Re: *Petition for Approval of Proposed Reliability Standard PRC-023-6*
Docket No. RD23-5-000

The North American Electric Reliability Corporation (“NERC”) hereby provides amended petition for approval of proposed Reliability Standard PRC-023-6, first filed in the above-captioned docket on March 2, 2023.¹ On October 10, 2023, the Office of Electric Reliability issued a letter seeking additional information regarding NERC’s proposed retirement of Requirement R2 of the currently effective PRC-023 standard.²

Figure C-1: Portion of an Unstable Swing

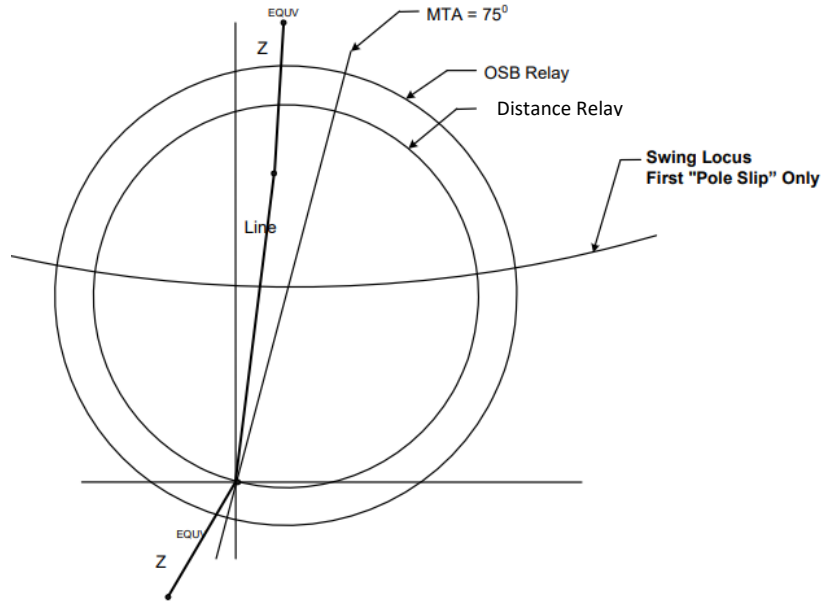
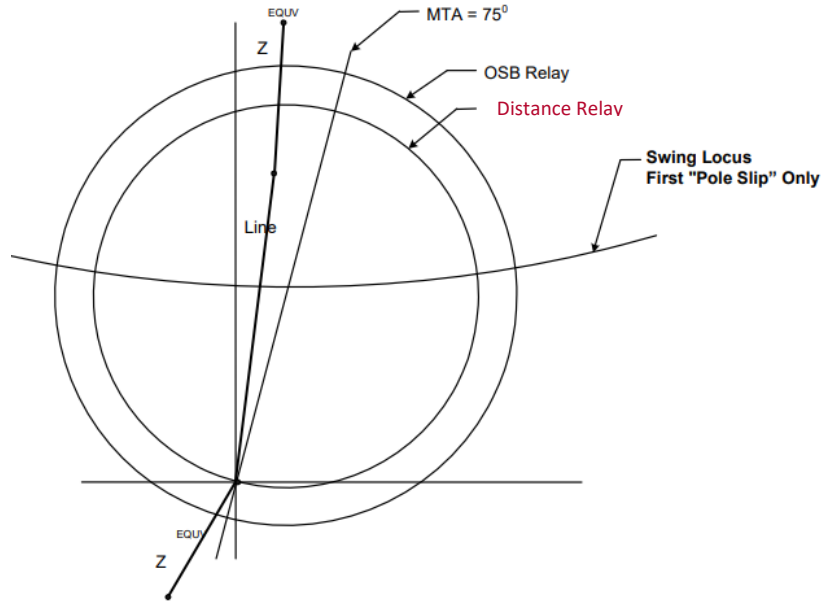
Figure C-1 illustrates the relationship between the out-of-step blocking relay and the tripping-distance relay, and shows a sample of a portion of an unstable swing.

Figure C-2: Out-of-Step Characteristics with Load

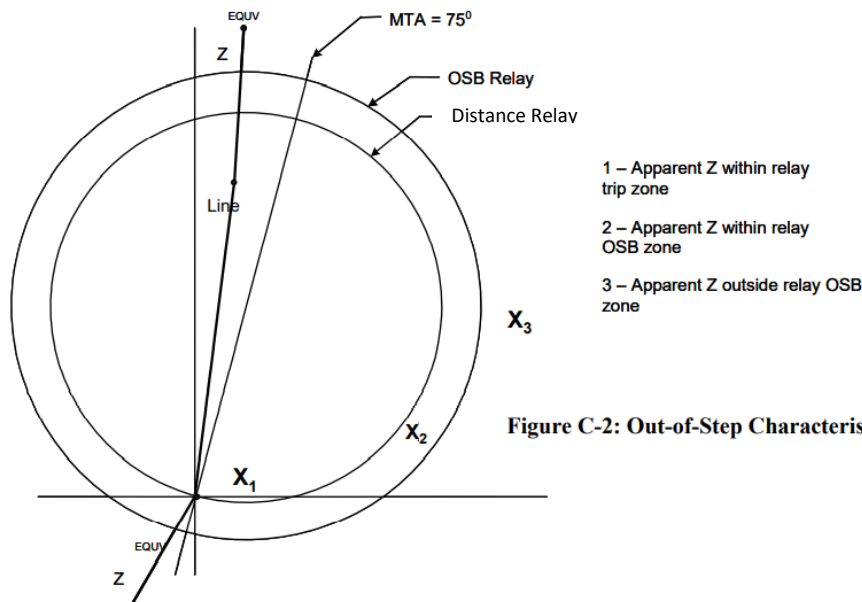
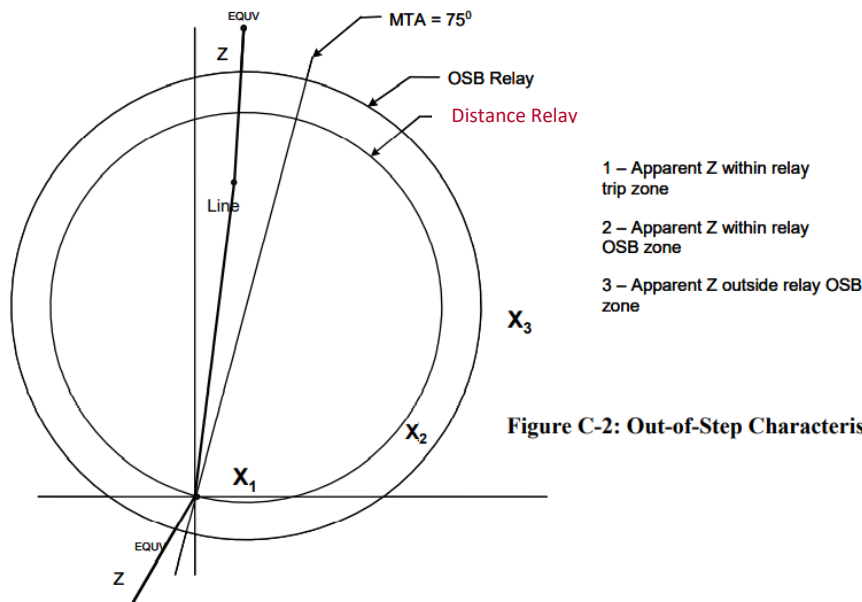
Figure C-2 illustrates a tripping-distance relay and out-of-step blocking relay, and shows the relative effects of several apparent impedances.
